6.1 PRE-APP FEEDBACK

· 152 - Horse Hospital Terrace Covering - vPPR Architects

6.2 COMMUNITY CONSULTATION

1. The extent of the canopy

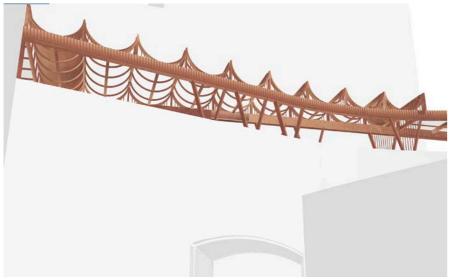
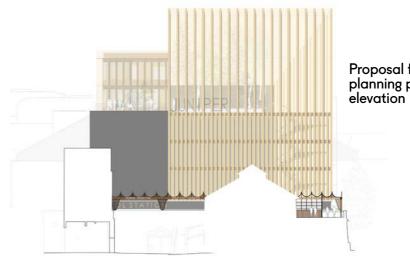
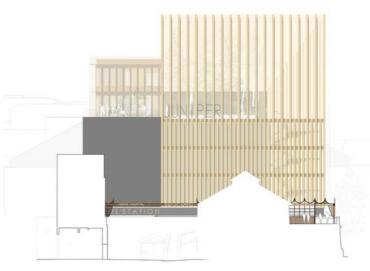
However it was raised during the pre-app whether a gap in the canopy may respond more appropriately to the north yard.

Design iterations were carried out to test options for a continuous covering or a physical break. While the gap historically framed views to the Roundhouse, the planning permission for the adjacent Morrisons site would entirely intercept this view. In light of the scale of the future massing, it seemed that a new relatively low intervention on the first floor of the Horse Hospital Terrace would positively contribute a layer of visual intrigue to the experience of the north yard, drawing visitors towards it. While a complete break in the terrace covering was not adopted due to both functional and gesthetic reasons, through the testing

process, it was agreed that this portion of the canopy would benefit from feeling lighter and therefore the fixed covering was removed and replaced with an open pergola, with an adjustable fabric canopy for rainy days to create temporary covering. This approach creates the sense of a gap, by seeing the sky directly through the wireframe, while at the same time providing a visual attractor.

3. Maker^s Alley

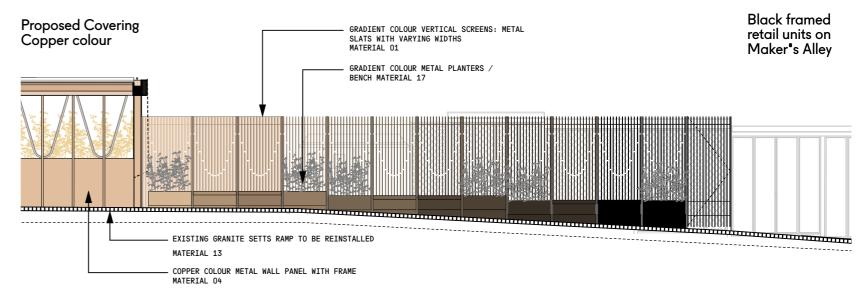
It was raised during the pre-app meeting that this application was an opportunity to improve the quality of the space at the top of Maker's Alley, which was previously not part of the application, and positively improve the setting of the Listed building.

This was agreed to be a positive opportunity to smarten the approach to the terrace, and consequently this area was incorporated into the application.

Maker's Alley Proposal gradienting between black framed retail units on Maker's Alley and the copper coloured terrace canopy, lined with planting, benches and vertical slatted screens, concealing a substation and mechanical plant

5. Canopy extent at top of Maker^s Alley

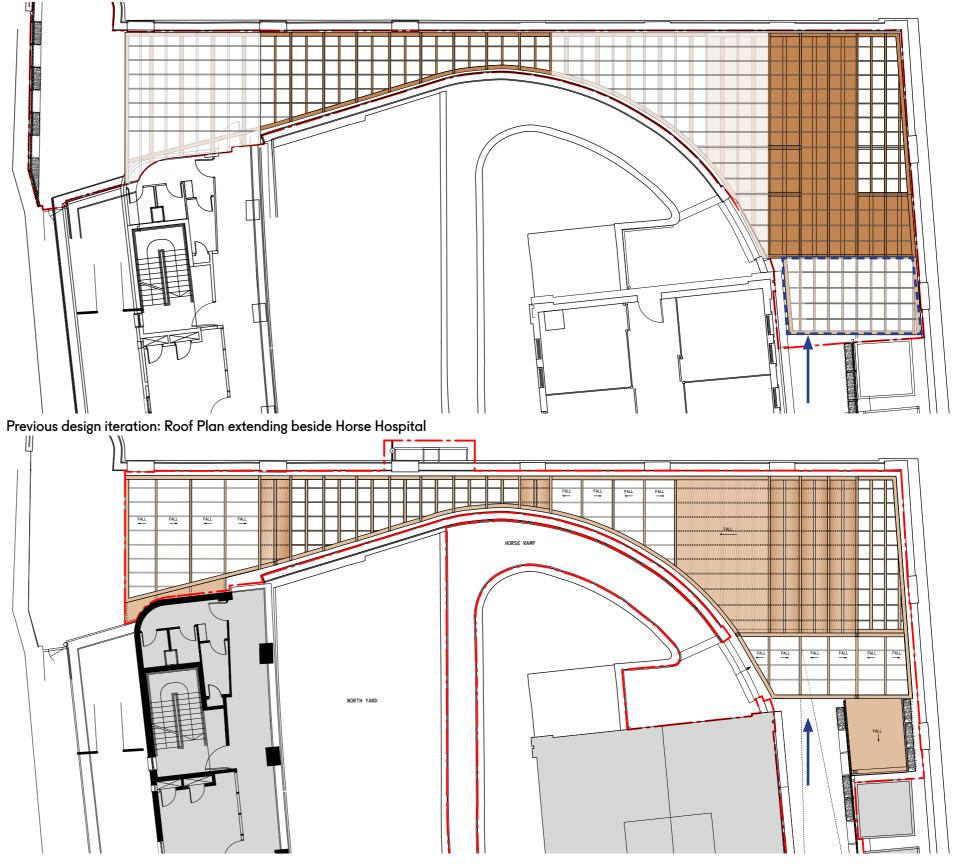
It was raised during the Pre-App that the relationship between the Horse Hospital and the covering could be improved at this sensitive junction.

The canopy roof has been pulled back to begin after the Horse Hospital ends, leaving a clear separation between new and old, and giving the Horse Hospital more open space around it.

CURRENT APPLICATION: Roof Plan pulled away from Horse Hospital

Logic of datum height to align with eaves of Horse Hospital

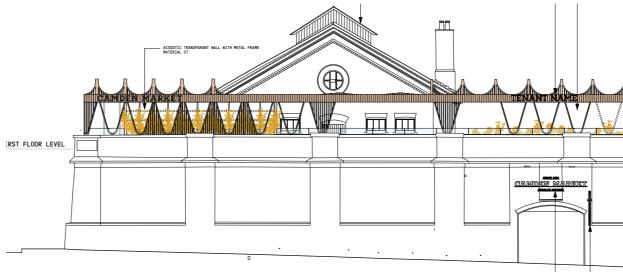
The feedback from the consultations raised the question of the height of the canopy, and whether it needed to be that height or whether it could be lower.

Design iterations of the canopy at different heights had been tested. The proposed canopy height has been carefully considered through these iterations and specifically responds to the proportions and datum levels of the Horse Hospital. The proposal is for the proposed datum line to align with the eaves of the Horse Hospital. The curved portion of the roof is generated from the proportions and levels of the porthole window on the Horse Hospital. The modest height of c.2.5m from FFL to flat roof of the proposal indicates that the design has prioritied the relationship to the Horse Hospital.

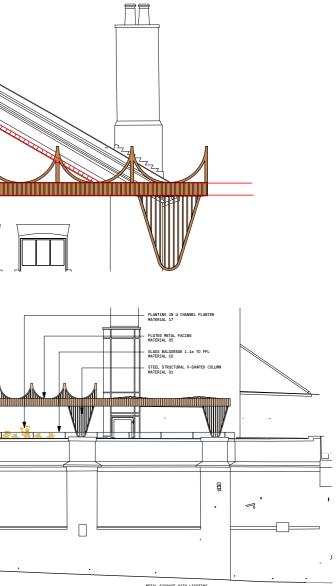
Consultees have expressed concerns regarding the name of the area. It was highlighted that "Horse Hospital" and "Terrace" were not appropriate

The proposal is therefore for generic signage for the market, with areas
